Hawaiian Memorial Park Cemetery Expansion Final Environmental Impact Statement

Kāneʻohe, Oʻahu, Hawaiʻi

September 2008
Volume 1

ERRATA SHEET

Figure 4: Concept Plan Former Proposed Action
Hawaiian Memorial Park Cemetery Expansion
Environmental Impact Statement
Kāne'ohe, O'ahu, Hawai'i

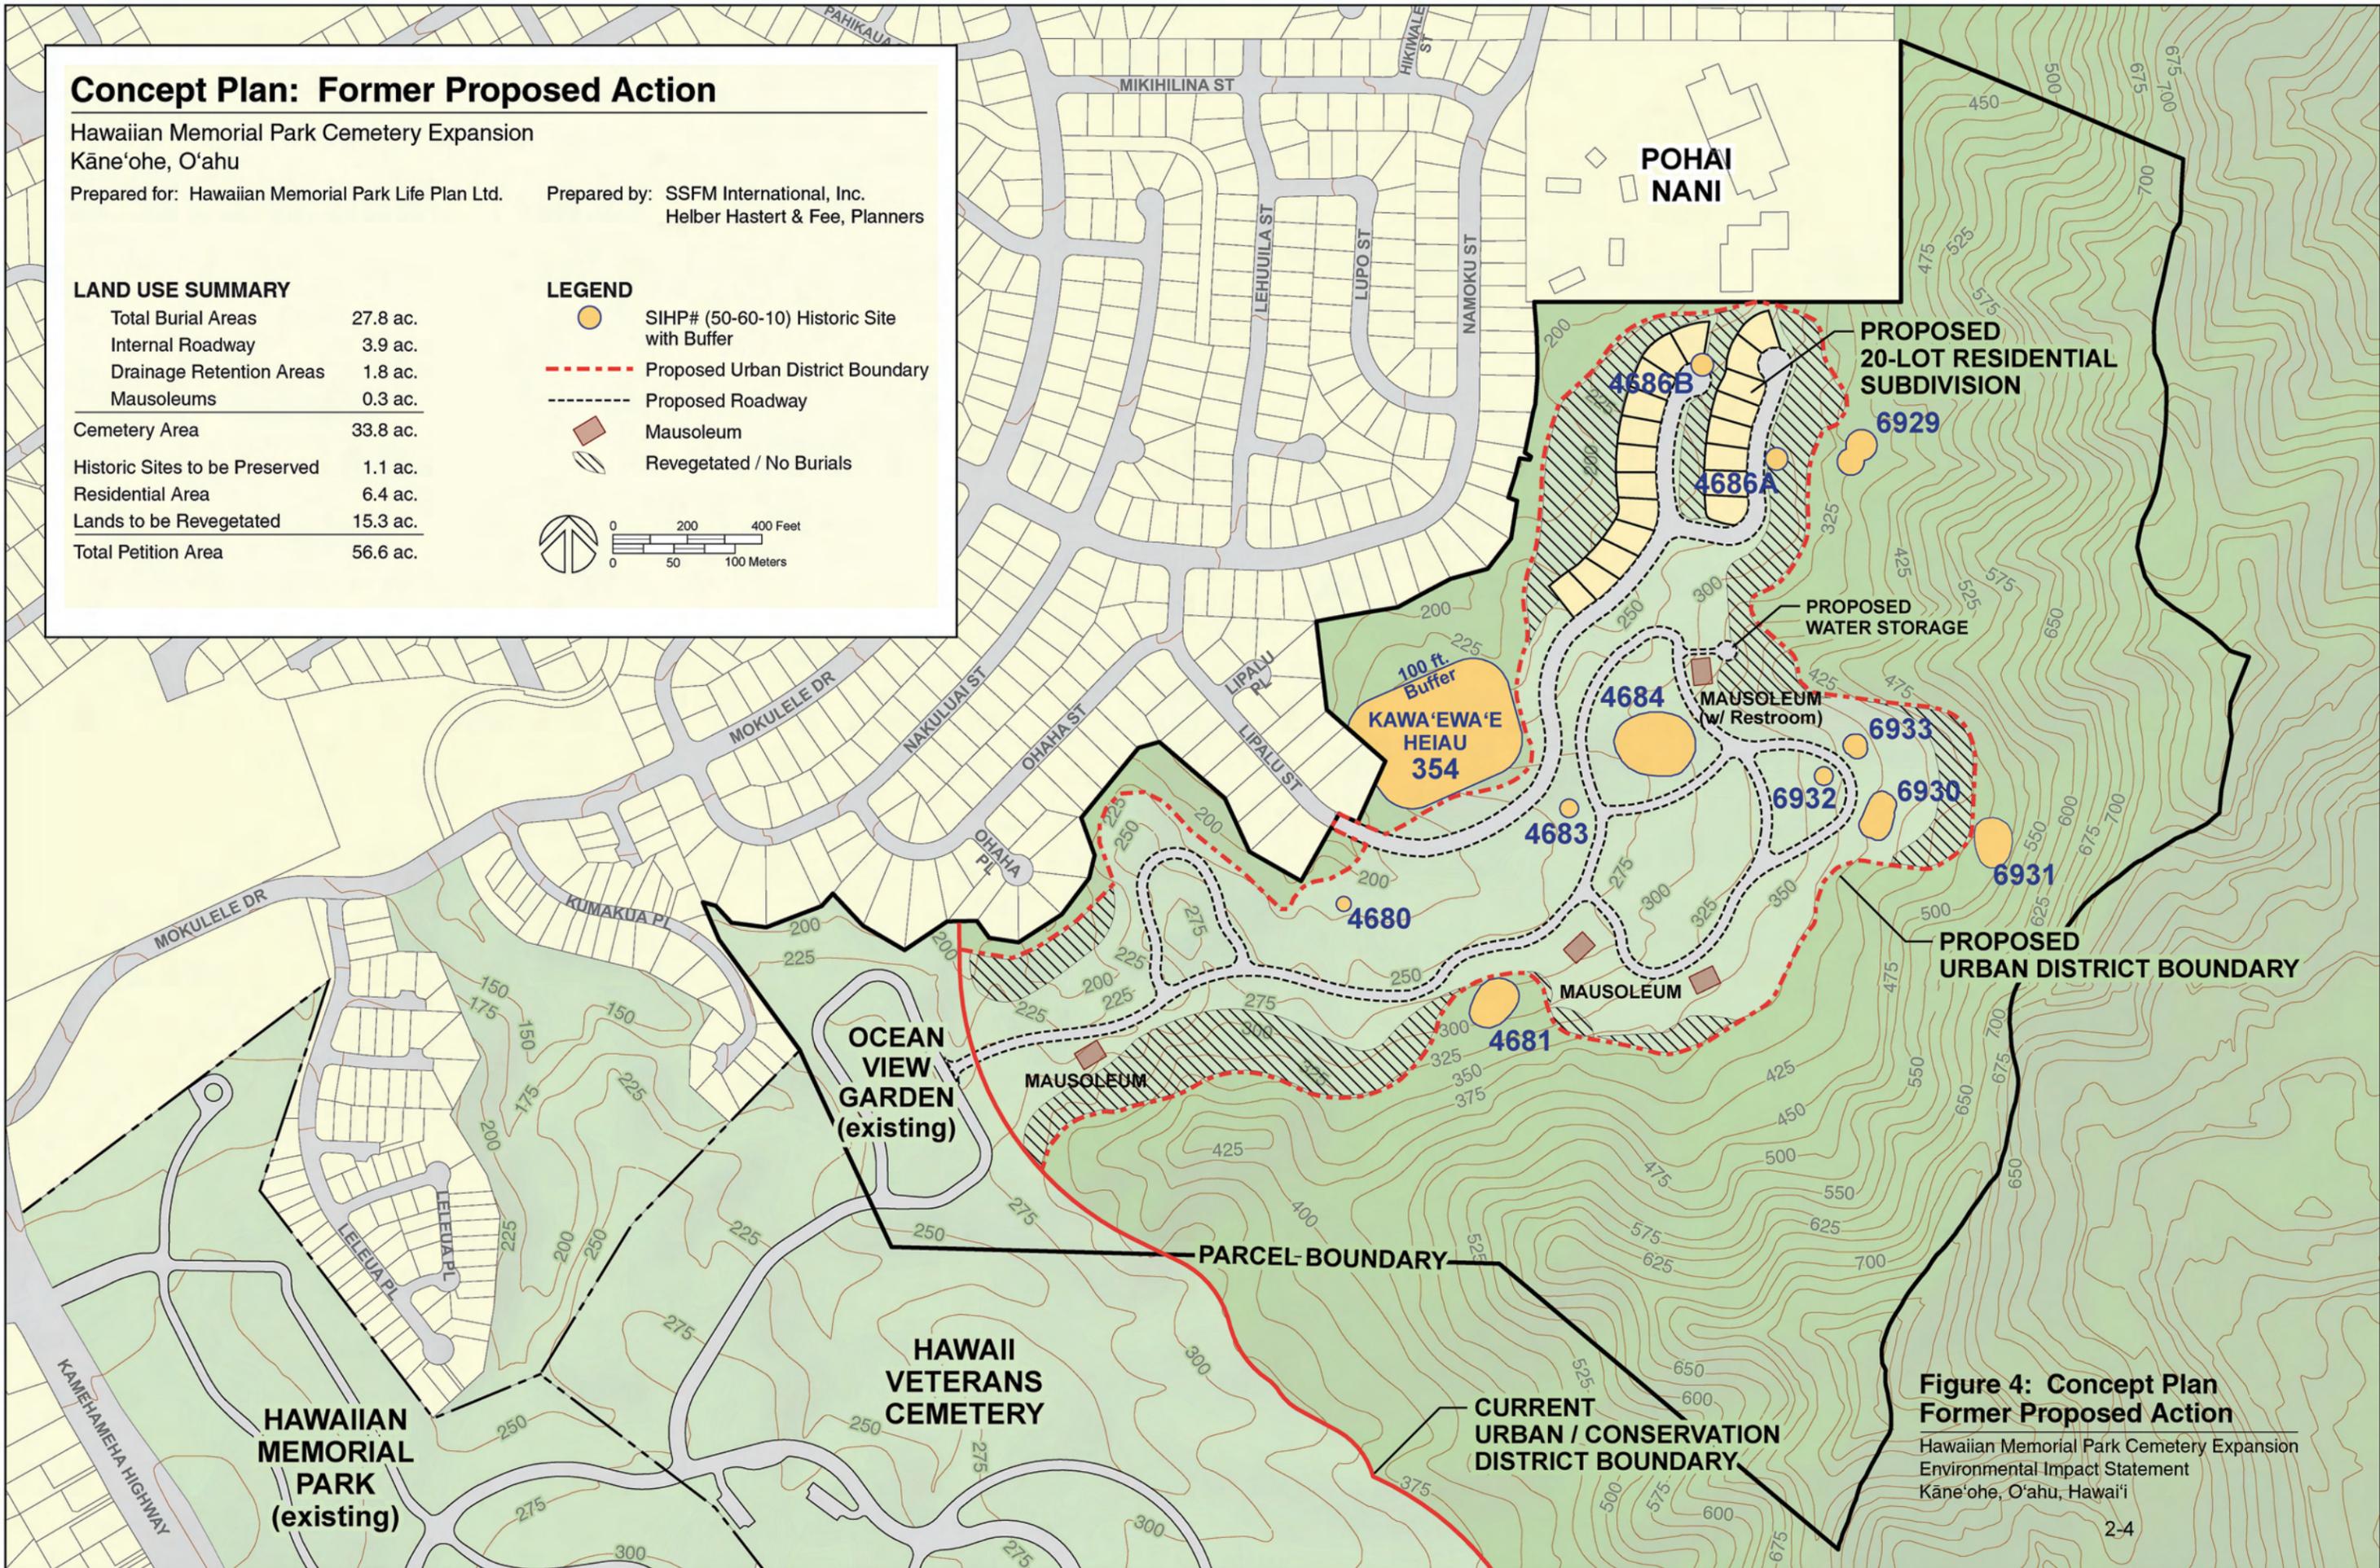
9. The SSFM International report is the first time that a "water treatment facility" is mentioned. Proposed water storage is shown on Figure 4 but there is no evidence of a "water treatment facility." The FEIS must provide details on the "facility" such as location, use and identify potential impacts to the environment.

Figure 15

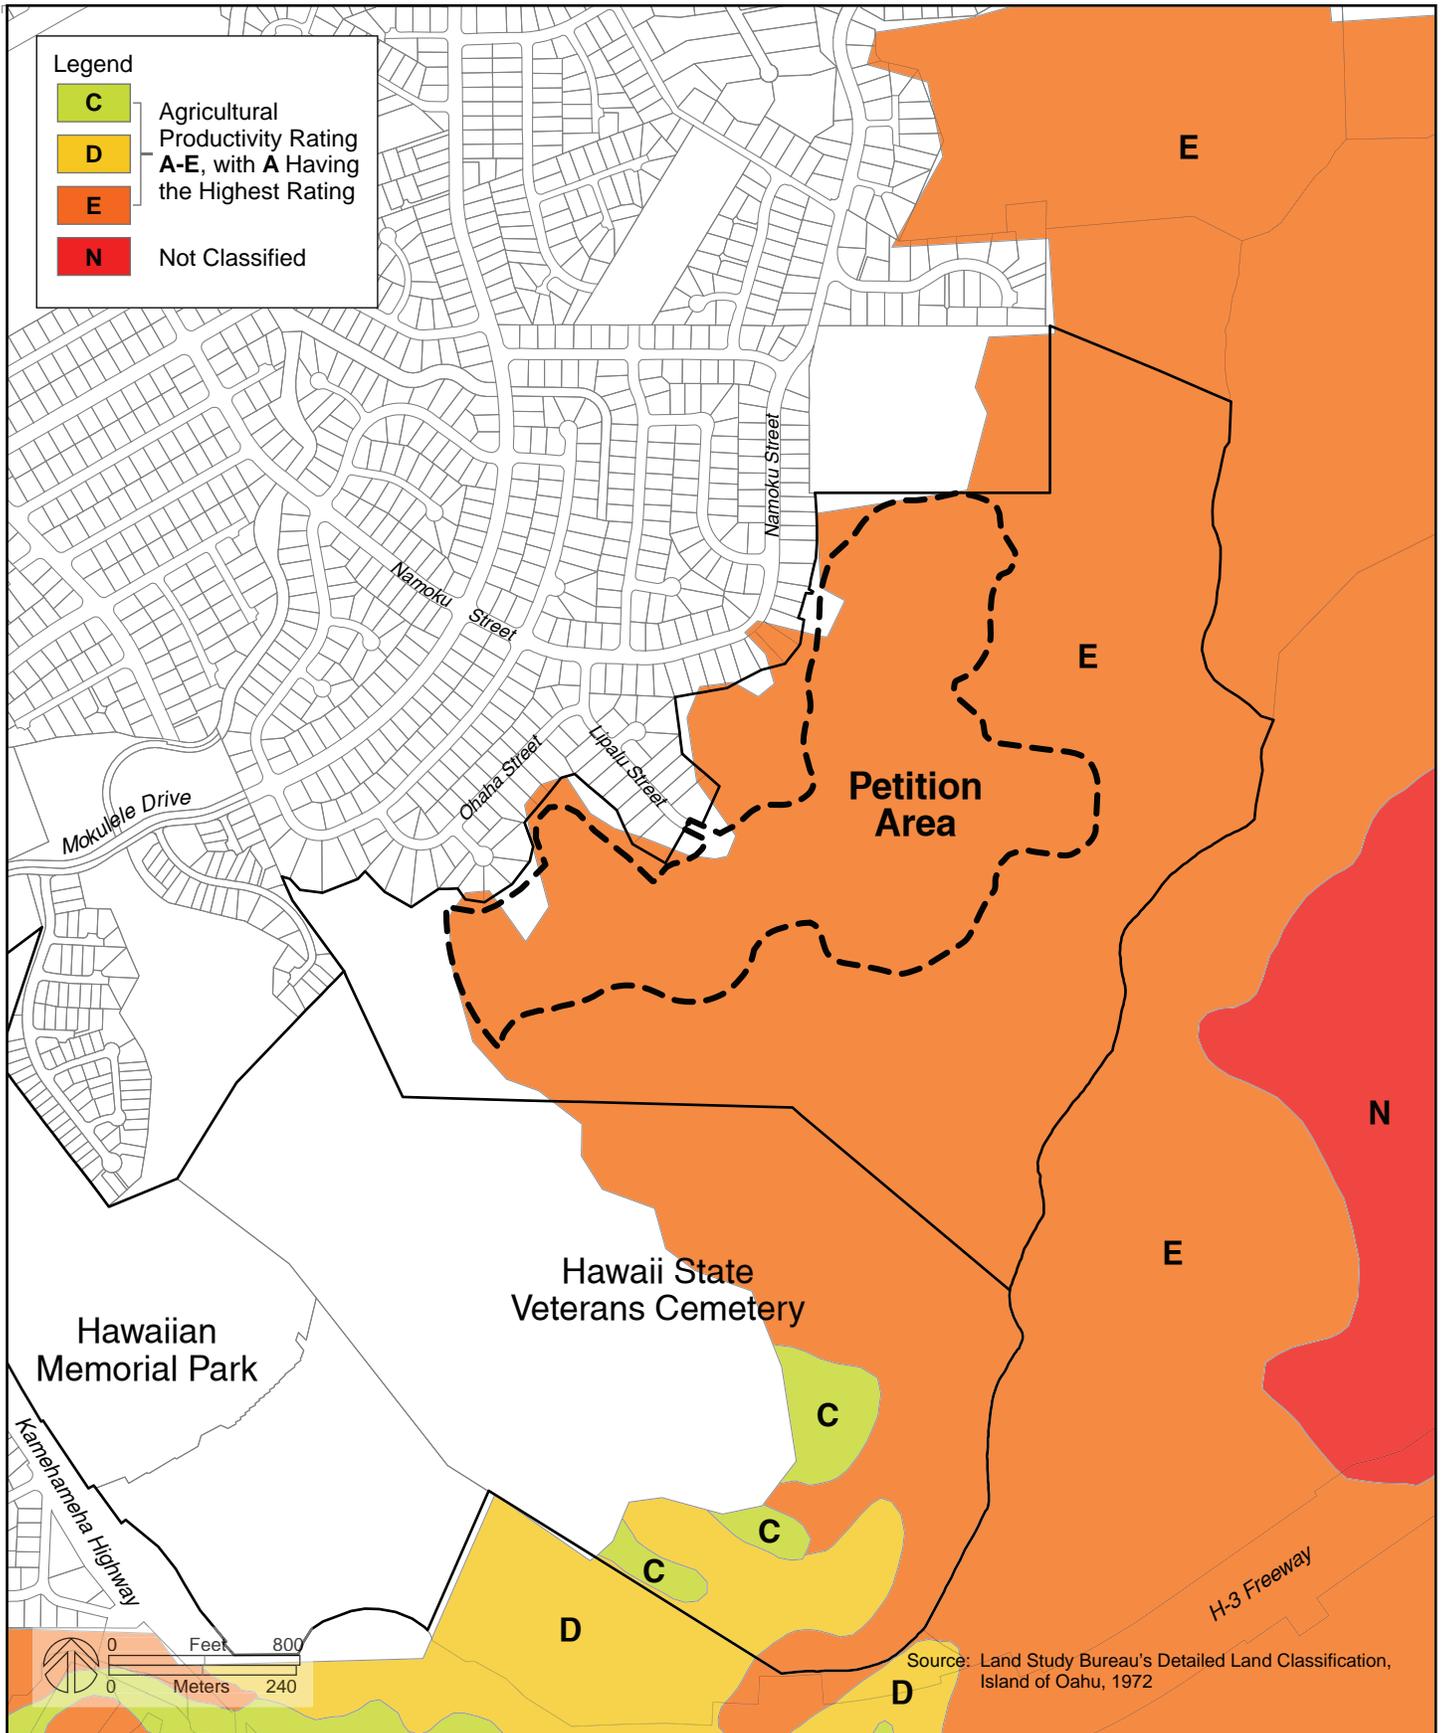
8. Figure 15 is missing a key with which to interpret LSB Productivity levels.

Response: Figure 15, LSB, has been changed in the Final EIS to include a legend clarifying the productivity levels shown on the Figure.

Figure 22a

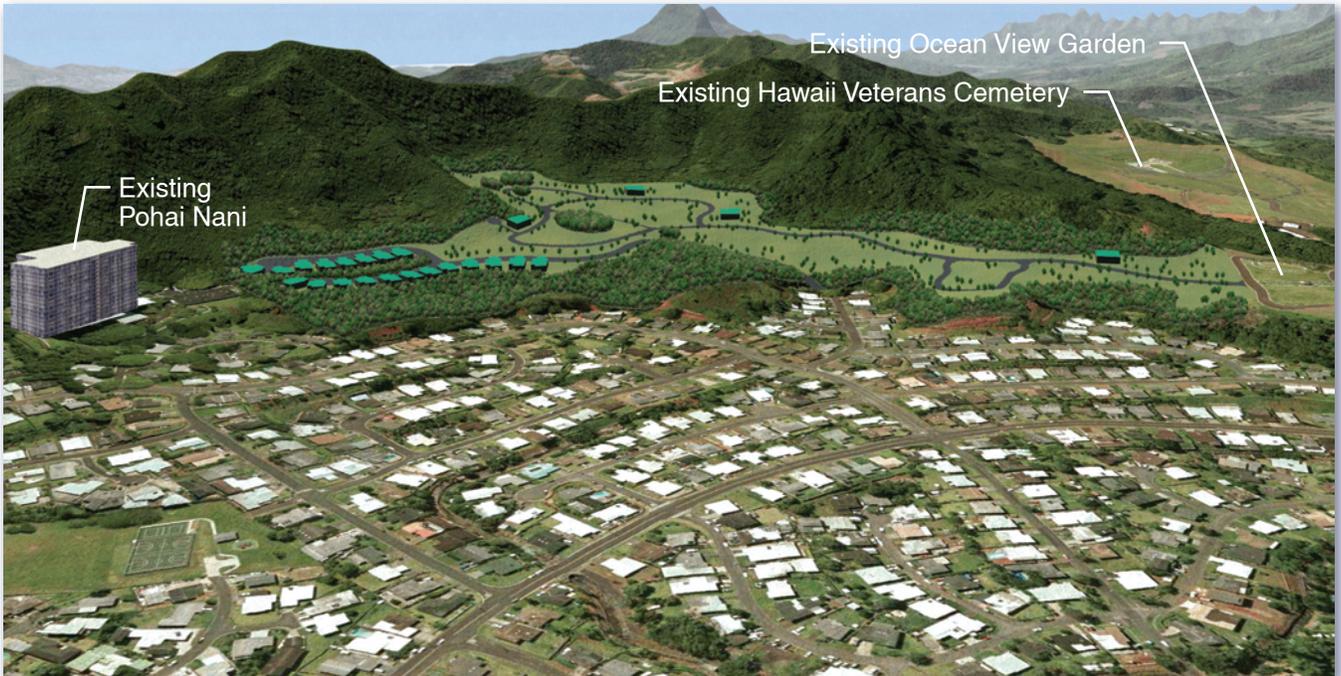
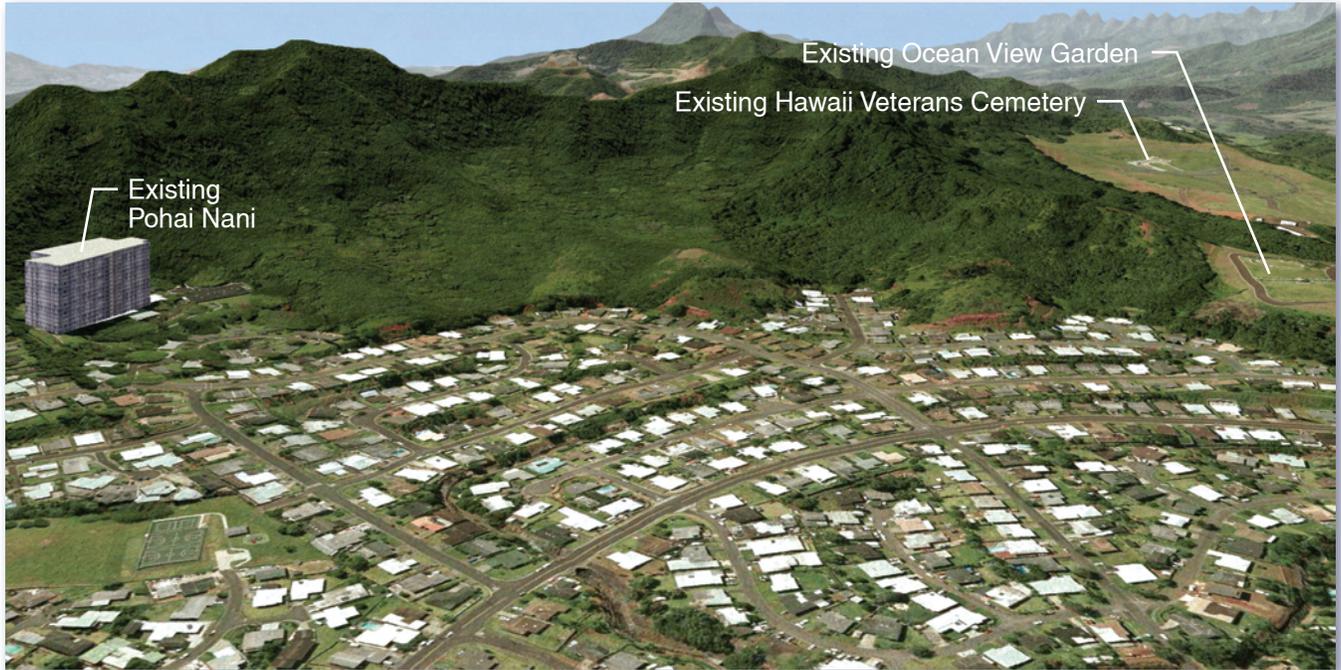
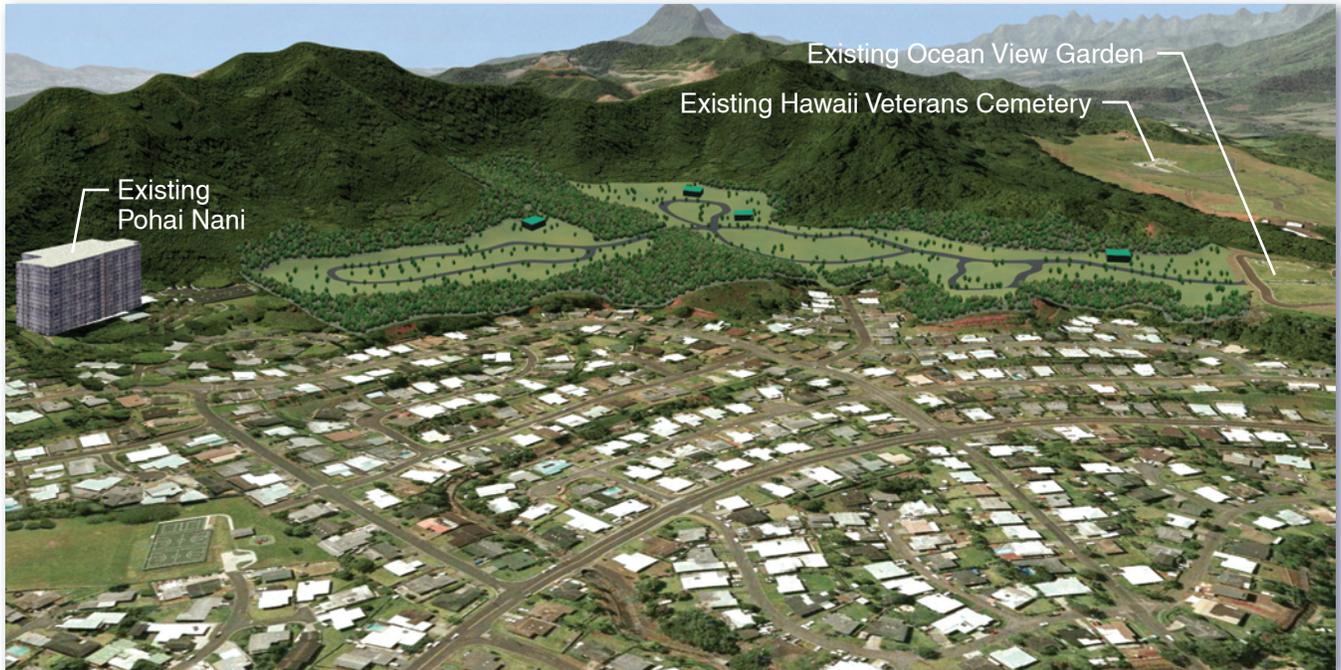
P. 4-42/ Figure 22	There could be a distinct possibility that residents at the new residential complex take advantage of easiness to cross over the bushes and grass (50 ft of more of buffer) and driver/walk thru the cemetery and come into the existing Ocean View Garden and subsequently into the existing HSVC areas, which does not have a guard in the night based on the provided perspective in Figure 22.

Also, clear illustrations of the proposed cut and fill areas should be provided. We recommend enlarging Figure 22 (an overall before-and-after site view) and providing close-up views (before and after) of Figure 22. Figure 28 a and b should also include cross sections of existing conditions before development. The elevations should be shown on the contour lines of the plans in the EIS.
2. **Scenic and Visual Impacts.** The above recommended illustrations would also make it easier for the reader to understand the discussion of scenic and visual impacts in Section 4.10.2. We recommend that the photos in Figure 23 be enlarged. Views from other vantage points should be included and evaluated such as H-3 Freeway and other sites near and far.

Figure 24

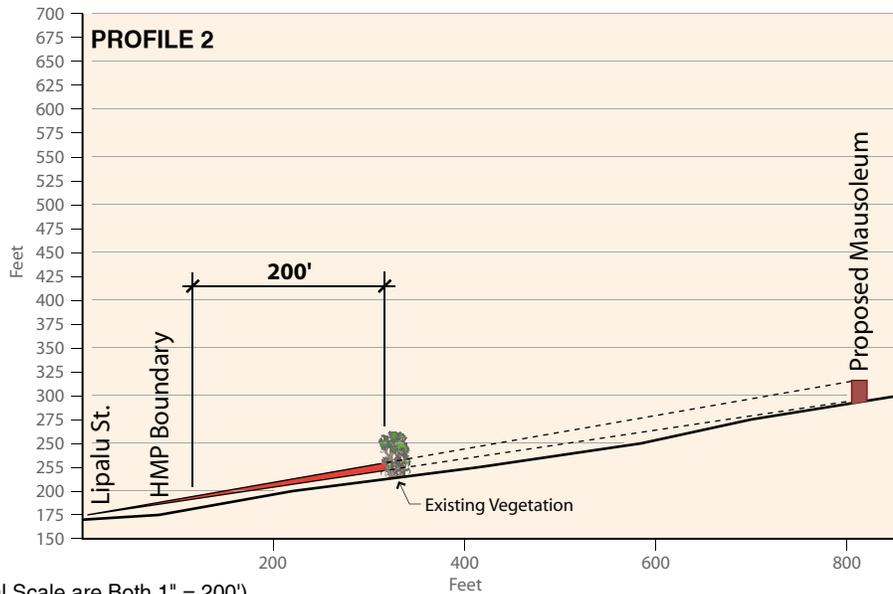
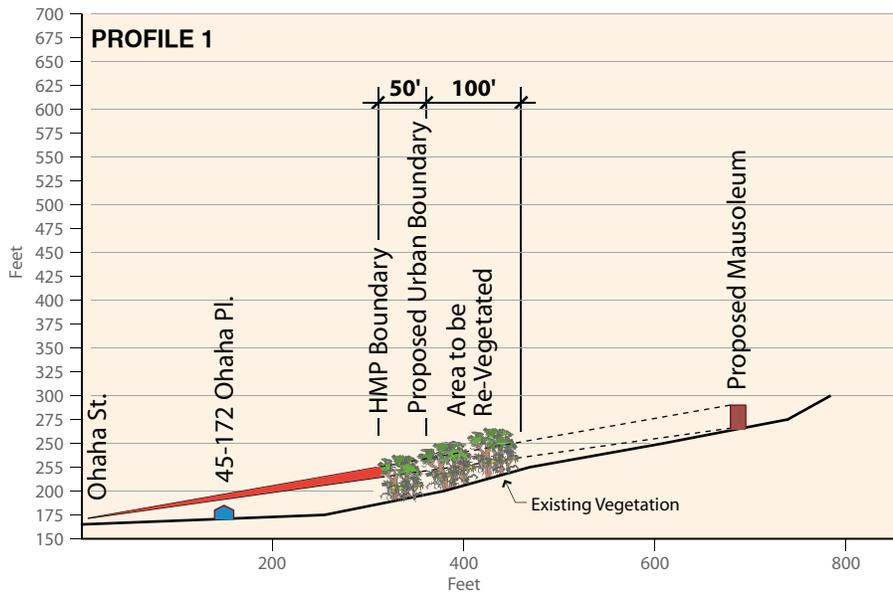
1. I disagree with the conclusion in the Draft EIS that there will not be significant negative impacts on the views in the surrounding neighborhood, Kaneohe Bay, and other areas of Kaneohe. The visual profiles in Figure 24, section 4-45 do not account for many other possibilities that exist. Scott Ezer told me that the starting point, or height of eye, used in profile 1 and 2 is 6 ft. Much more of the petition area would be visible from a height of eye of 8 feet, as in the case of riding in a city bus. Even worse would be a height of eye of 18 feet, as in the view from the second story of a house. Please show the impacts from these additional heights of eye.

Response: The Draft EIS will include additional scenic profiles (Figure 24) that illustrate the dimensional relationships of several view planes of the project from the Pikoioa neighborhood. These profiles will be accompanied by scales and measurements.
